ADDENDUM NO. 1

DEERFIELD
Federal Aid Project No. BFL(BR-OFF)-0032(052)X
Bridge Replacement, D-06-001,
Upper Road Over Deerfield River

Transmitting revisions to the Contract Documents as follows:

Revised Plan Sheets 47, 49, 50, 51, 52, 61 & 63 of 92.

NOT TO SCALE

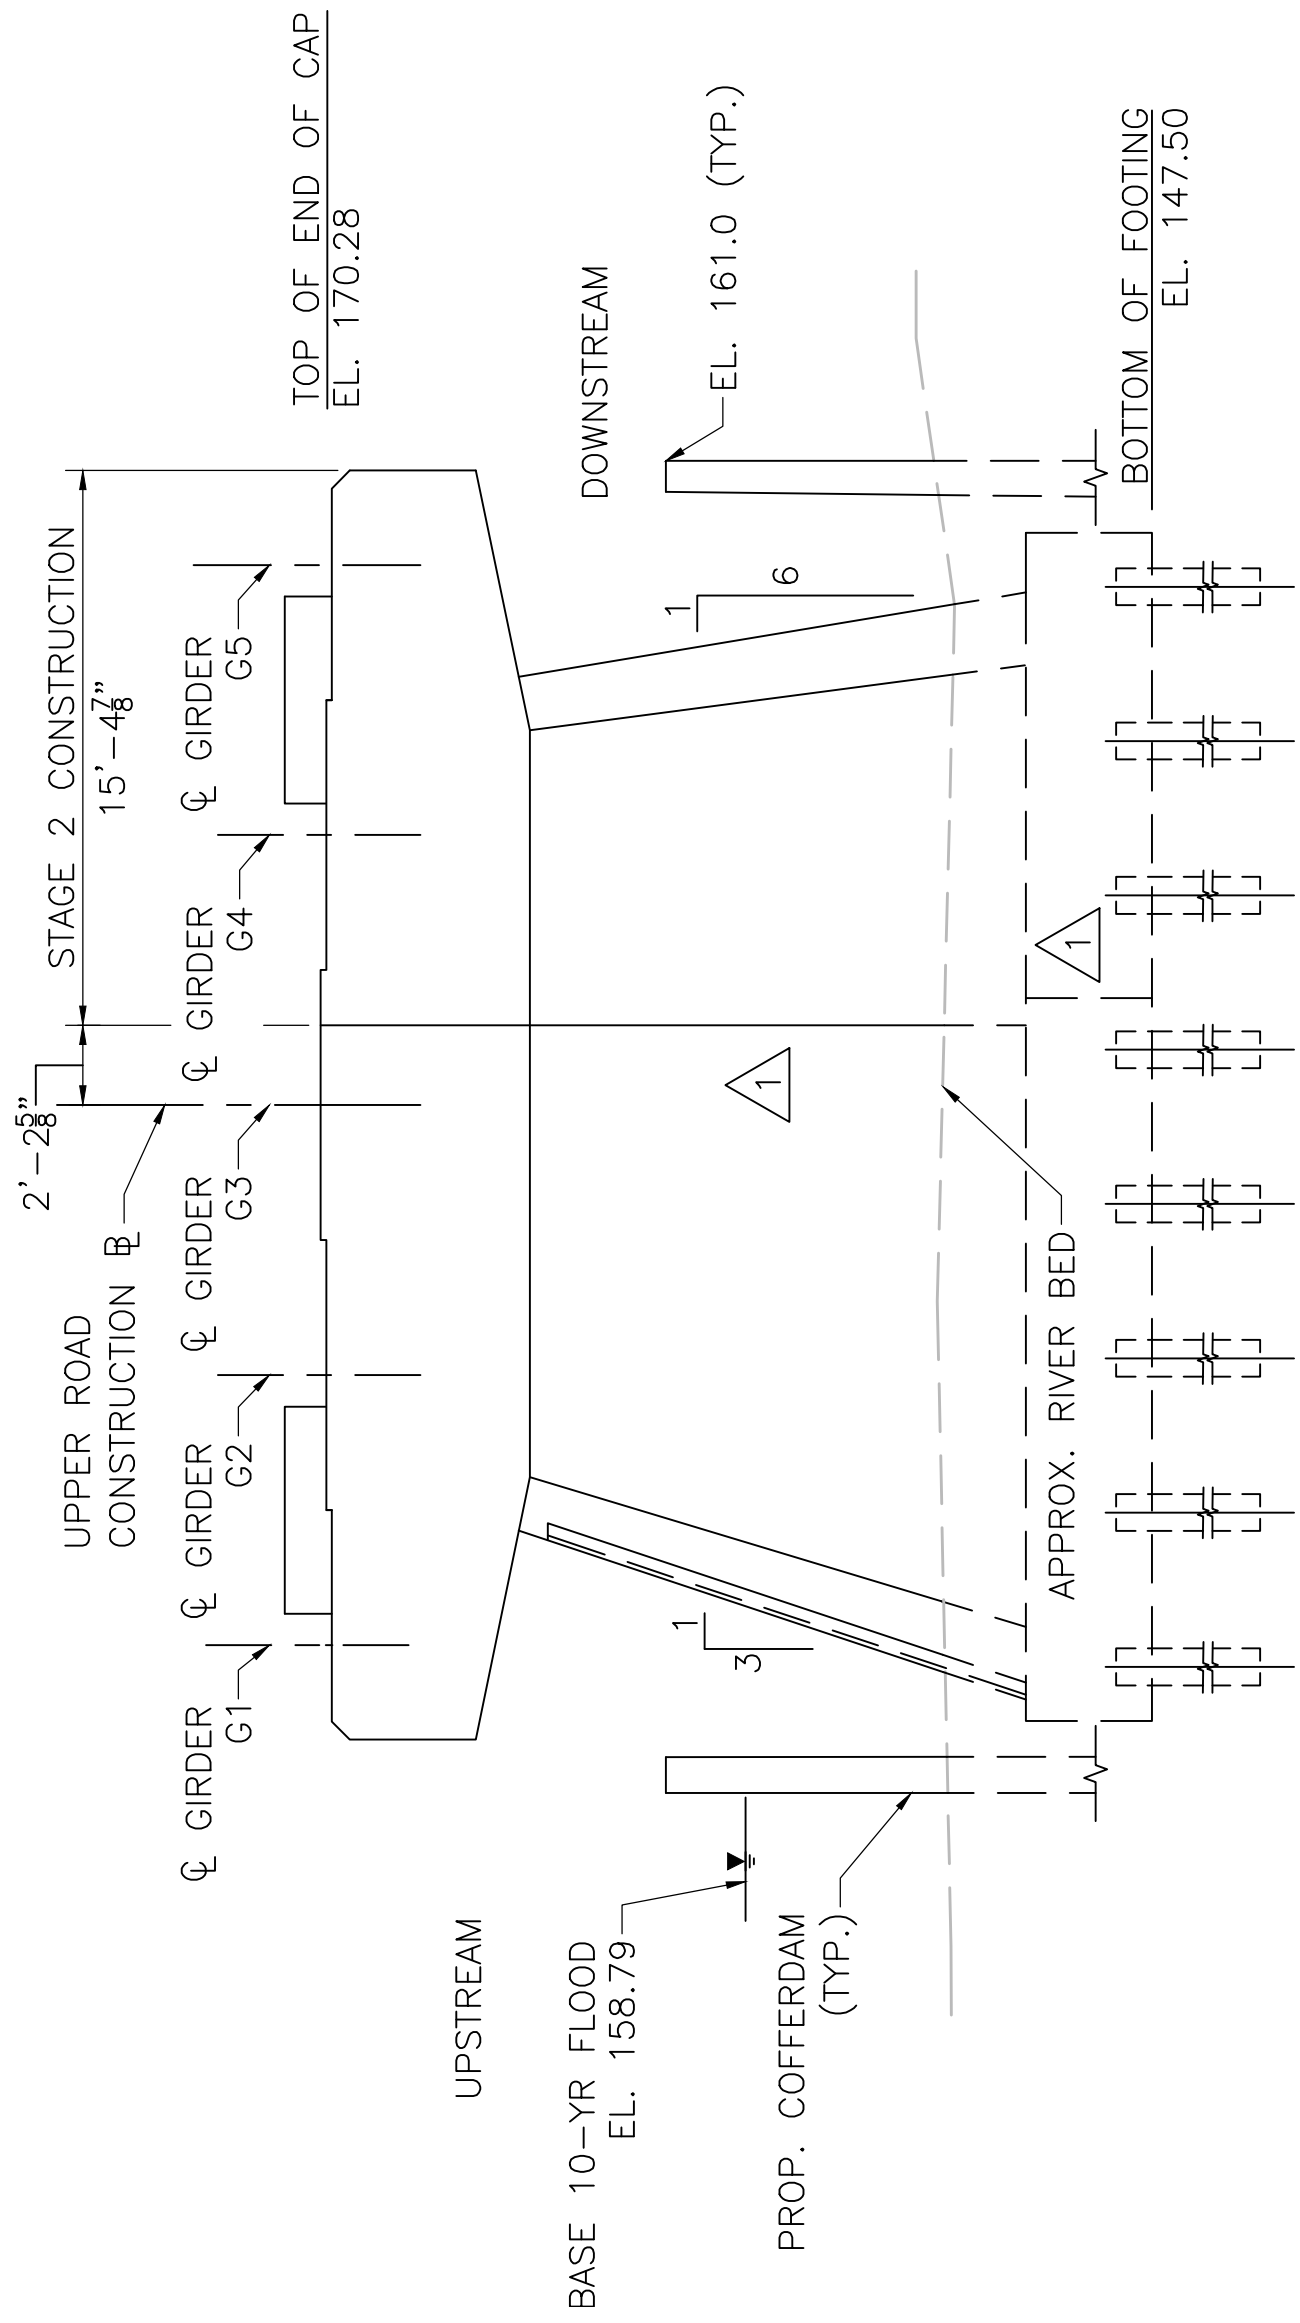
Can Pier 1 be installed and built with construction joints in the footing and stem for the phased construction approach, like what is shown for construction joints in the south abutment?

For pile locations requiring multiple splices due to headroom limitations, please confirm the required pile driving criteria, including any restrictions on driving spliced piles, maximum allowable hammer energy, splice inspection requirements, and any special procedures necessary to achieve the specified pile capacity.

See revised Plan Sheets 47 of 92 (11 of 41), 49 of 92 (13 of 41), 50 of 92 (14 of 41), 52 of 92 (16 of 41), 61 of 92 (25 of 41), and 63 of 92 (27 of 41) issued via this addendum.

- 2A. INSTALL THE REMAINING PROPOSED DRIVEN H-PILES AT THE SOUTH ABUTMENT AND AT PIER 1.
- 2B. CONSTRUCT THE STAGE 2 LIMITS OF THE PROPOSED ABUTMENTS, PIER 1, AND WINGWALLS.

June 26, 2026	STAGE 1 LIMIT ALTERED
May 30, 2026	ISSUED FOR CONSTRUCTION
DATE	DESCRIPTION
THIS SHEET IS APPROVED FOR CONSTRUCTION BY MASSDOT AUTHORIZED SIGNATORY: STATE BRIDGE ENGINEER	
USE ONLY PRINTS OF LATEST DATE

COFFERDAM LAYOUT AND DETAILS

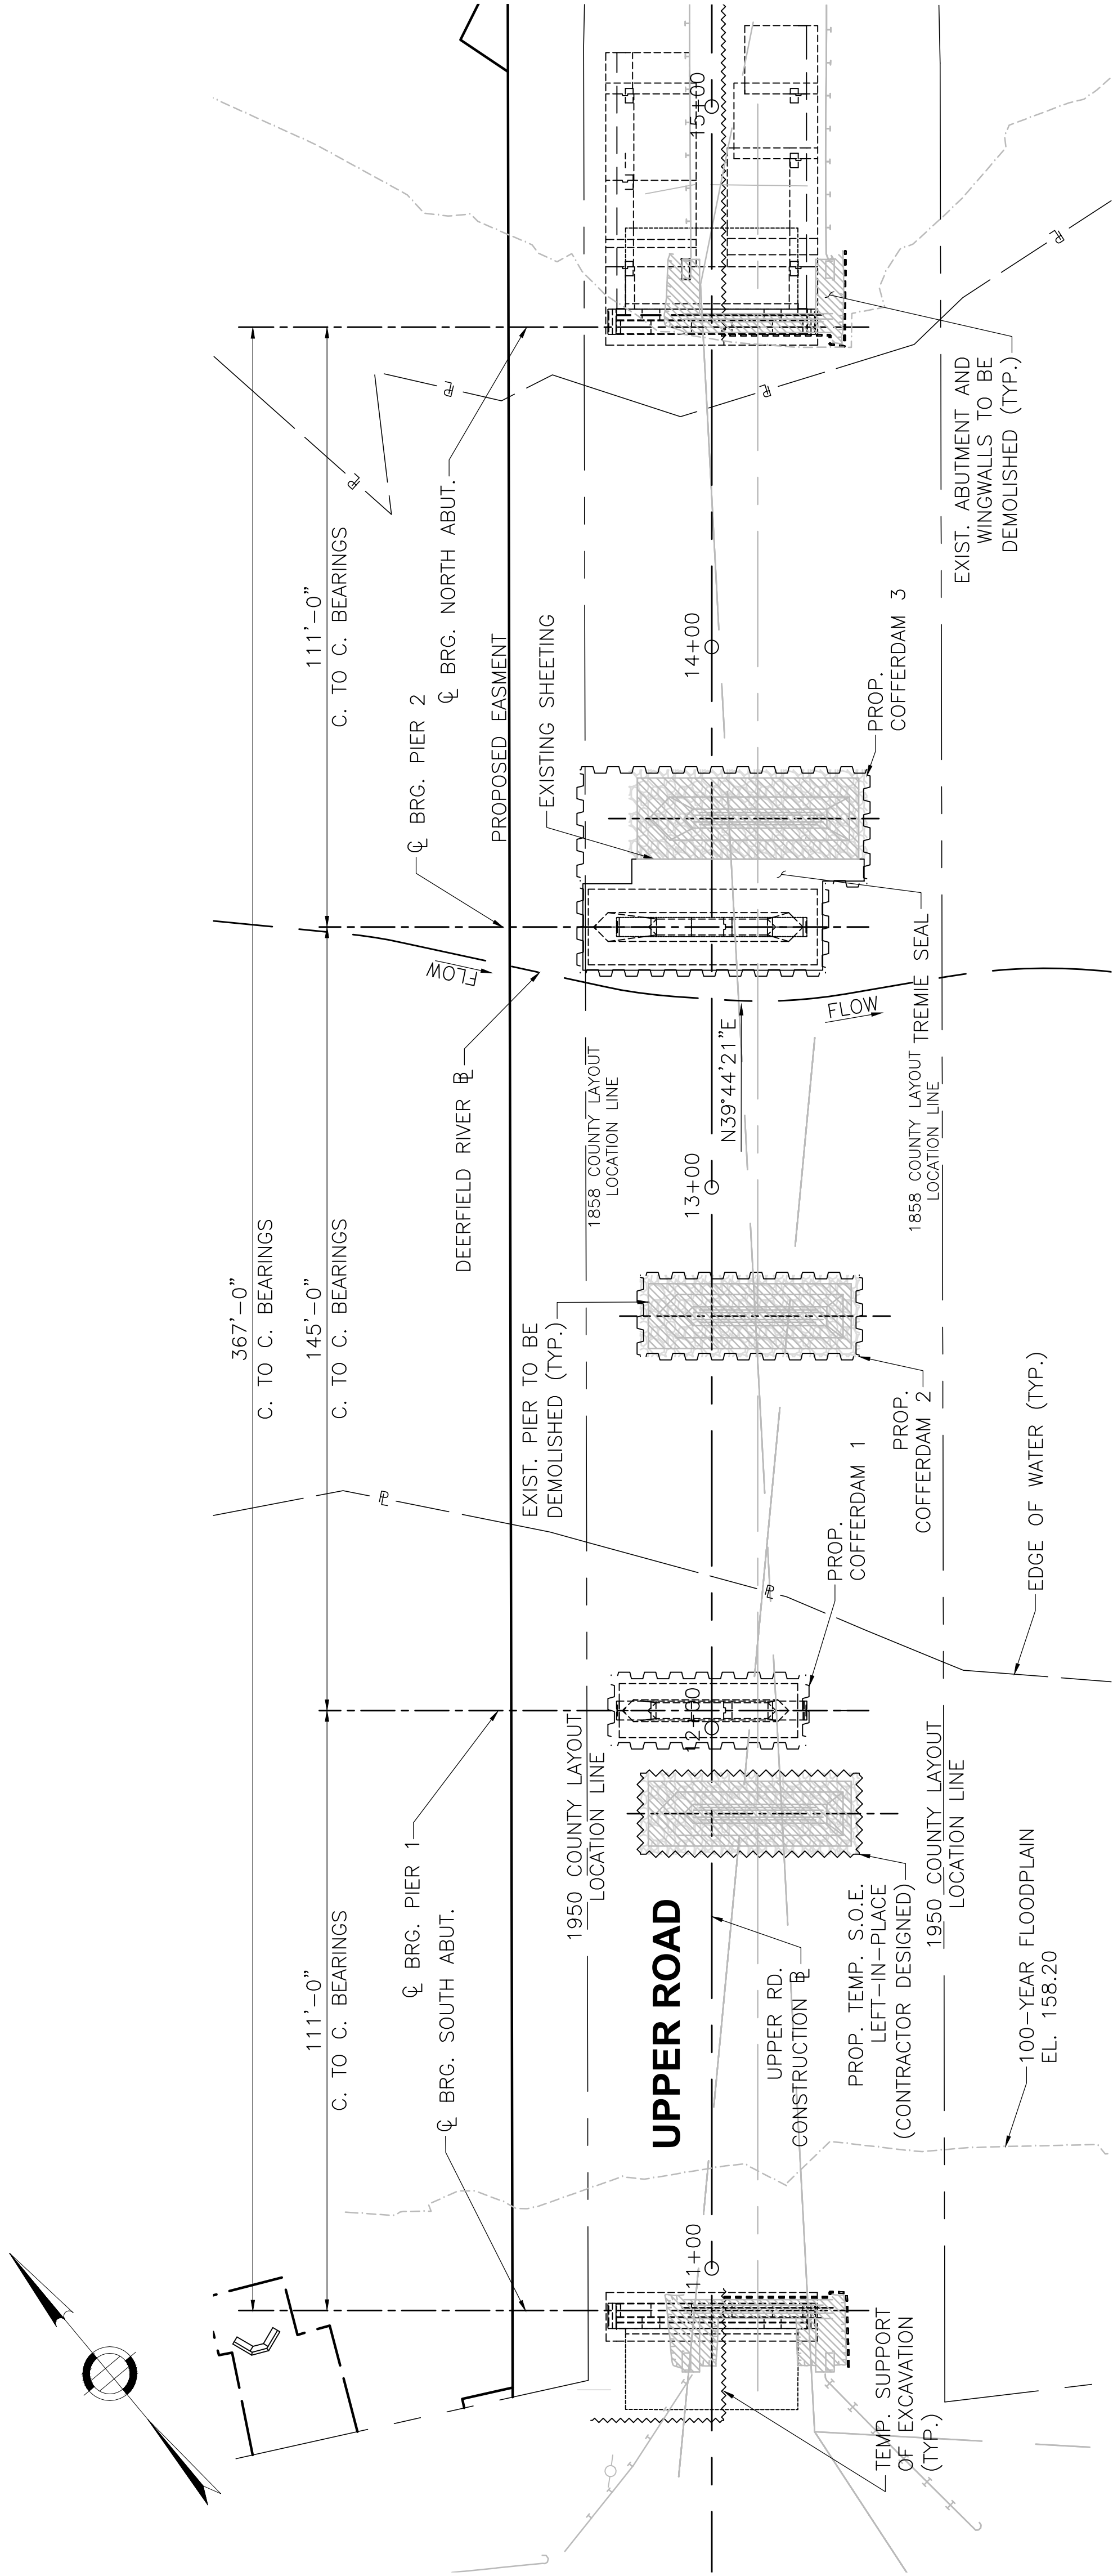
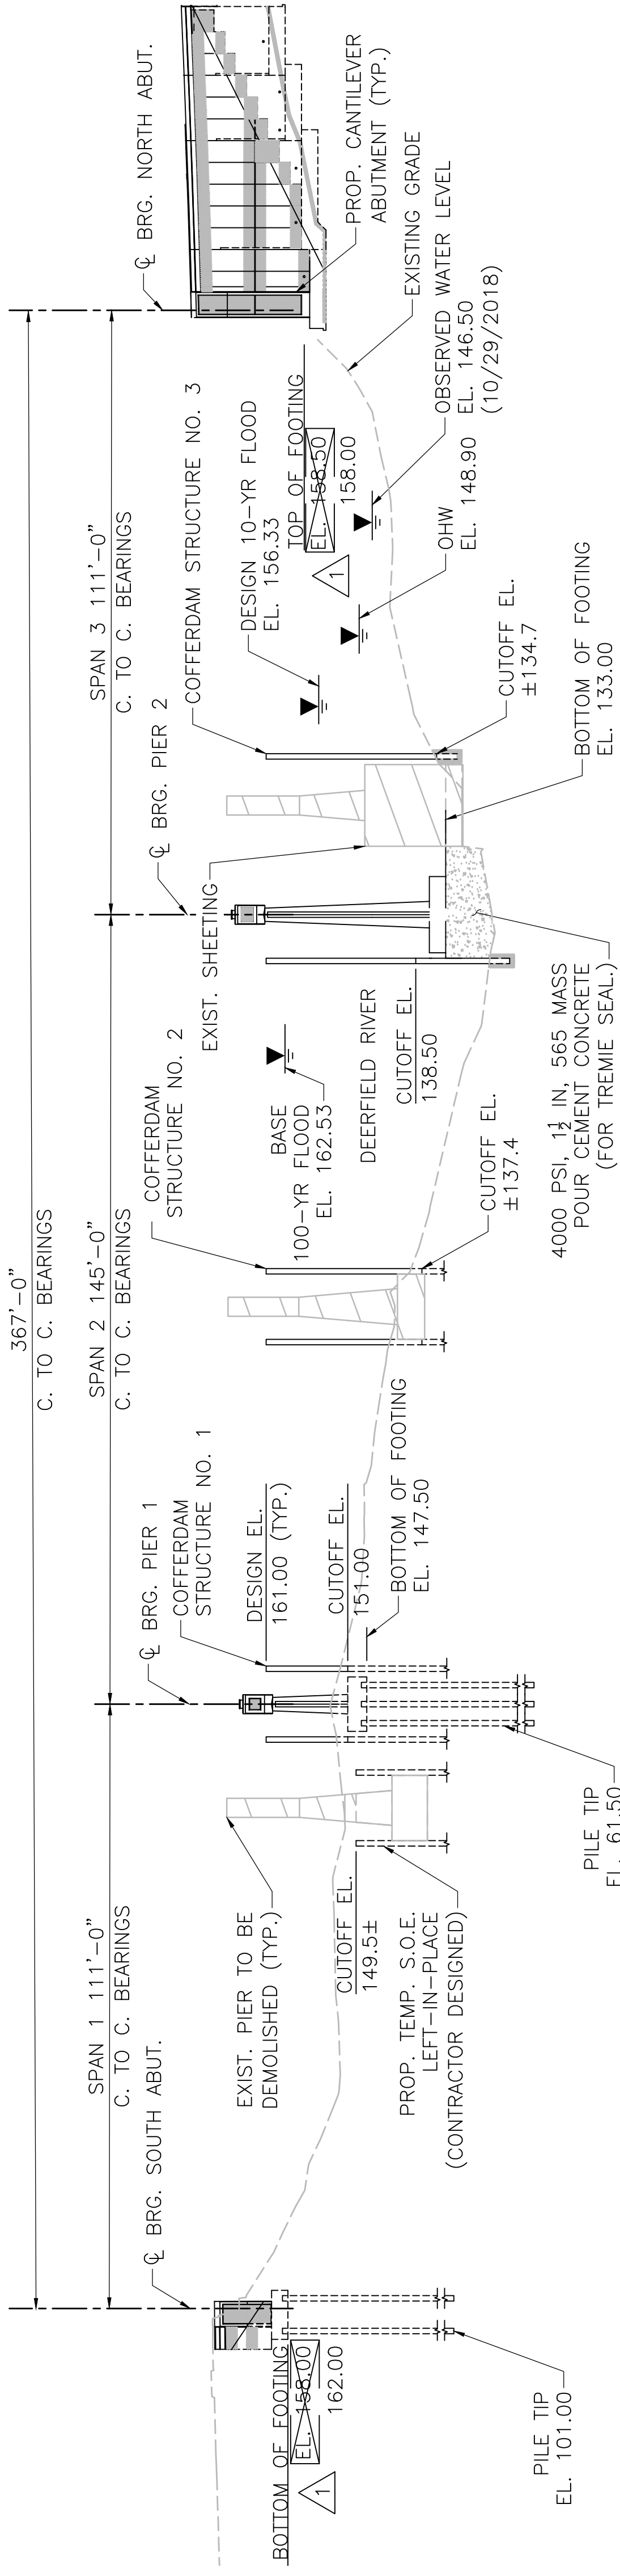
Sheet 46/53 shows the bottom of south abutment footing elevation of 162.00. Drawing 51 shows south abutment El 158.00. Please confirm the elevation of the south abutment.

See revised Plan Sheet 51 of 92 (15 of 41) issued via this addendum.

June 26, 2026	REVISED FOOTING ELEVATIONS
May 30, 2026	ISSUED FOR CONSTRUCTION
DATE	DESCRIPTION
THIS SHEET IS APPROVED FOR CONSTRUCTION BY MASSDOT AUTHORIZED SIGNATORY: _____ STATE BRIDGE ENGINEER	
USE ONLY PRINTS OF LATEST DATE
